CITY OF SHELBYVILLE

PLAN COMMISSION

MEETING DATE: July 22nd, 2019

Case Number & Name:	PC 2019-11 Twin Lakes Estates Section II & III Primary Plat			
Petitioner's Name:	D.R. Horton dba Westport Homes			
Owner's Name:	Twin lakes LLC			
Petitioner's Representative:	Brain Tuohy			
Address of Property:	Approximately 37 acres north of Twin Lakes Blvd. and east of Amos Road			
Subject Property Zoning Classification:	PD – Planned Development District			
Comprehensive Future Land use:	Single Family Residential			
	North	East	South	West
Surrounding Properties' Zoning Classifications:	R1 – Single Family Residential	R1 – Single Family Residential	R1 – Single Family Residential	R1 – Single Family Residential
Surrounding Properties' Comprehensive Future Land Use	Single Family Residential	Single Family Residential	Single Family Residential	Multi-Family Residential
History:	The original PUD was approved in 2006, and has since been revised multiple times to adjust with real-estate market trends. At the May 28 th , 2019 Plan Commission meeting, a PUD revision was approved.

2. The planning staff have prepared an exhibit that indicated different areas of the proposed plat that will be addressed in the staff report. That exhibit can be found towards the end of this packet and is labeled "Exhibit A: Overall Site Plan".

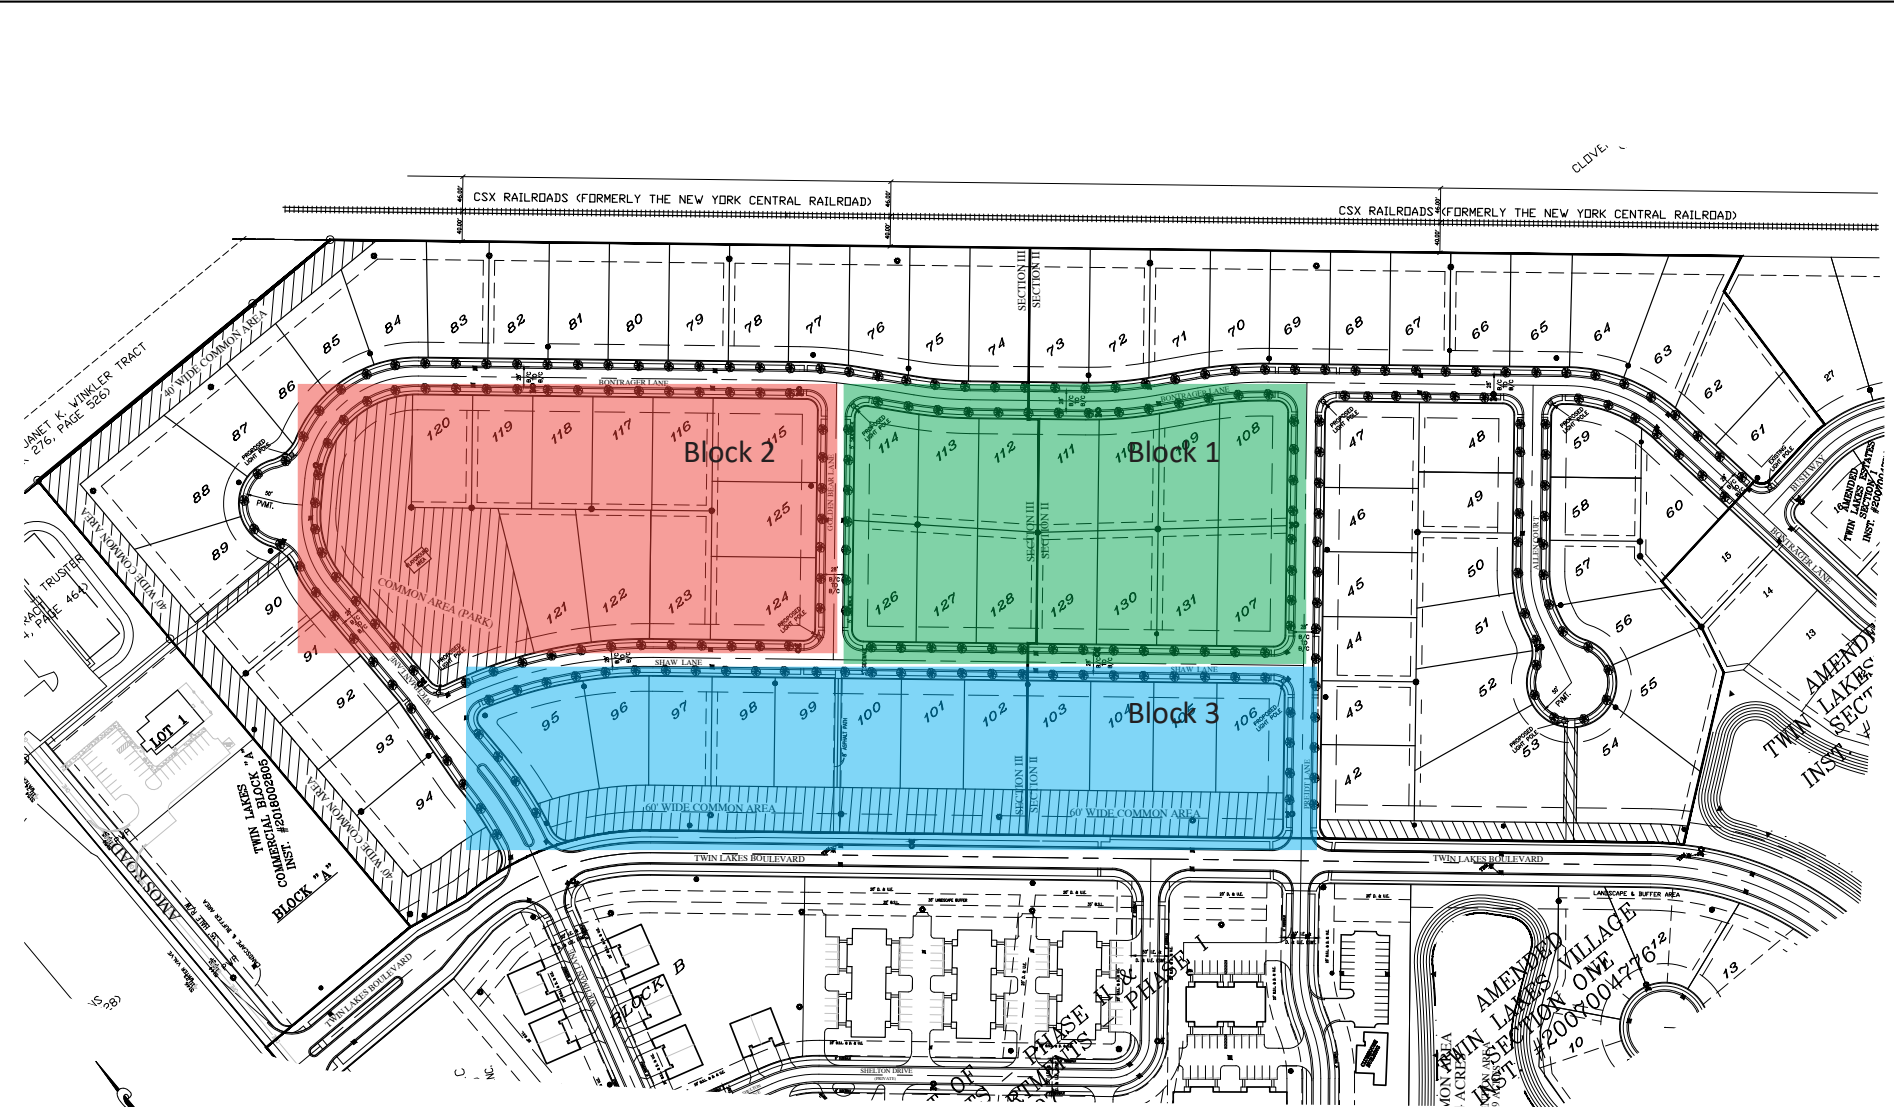
Blocks shall have sufficient width to provide for two (2) tiers of lots of appropriate depth and not exceed 800 feet in length, nor be less than 200 feet in length. Blocks exceeding six hundred (600) feet in length maybe required to provide a five (5) foot wide common area or easement through the block in order to accommodate utilities, drainage or pedestrian pathways. Block 1 and Block 2 (see attached Exhibit) are less than eight hundred (800) feet in length; Block 1 is six hundred and twenty-five (625) feet in length and Block 2 is five hundred and fifty (550) feet in length. Block 3 is 1175 feet in length; over the eight hundred foot maximum. **Block 3 will require a waiver from the standards.**

The UDO sets the maximum block length at eight hundred (800) feet. The block along Shaw Lane, comprising lots 95 through 106 (Shown as Block 3 in the Exhibit), measures approximately nine hundred (900) feet. In order to limit the number of curb cuts onto Twin Lakes Boulevard, this block needs to exceed the maximum length.

The UDO requires blocks exceeding six hundred (600) feet in length to provide a five (5) foot wide common area or easement through the block in order to accommodate pedestrian pathways. The block between Shaw Lane and Bontrager Lane (to the north and south) and Golden Bear Lane to Preidt Lane (to the east and west), comprising lots 107-114 and lots 126 to 131 (shown as Block 1 on the exhibit), measures six hundred twenty-five (625) feet. This block requires a five (5) foot easement. However, based on the internal circulation plan for the site, Planning Staff recommends not providing this pedestrian pathway. Instead, Planning Staff would request a wider sidewalk on Golden Bear Lane that aligns with the pedestrian path between lot 99 and lot 100.

1. Provide an additional three (3) feet in width to the sidewalk on the east-side of Golden Bear Lane.
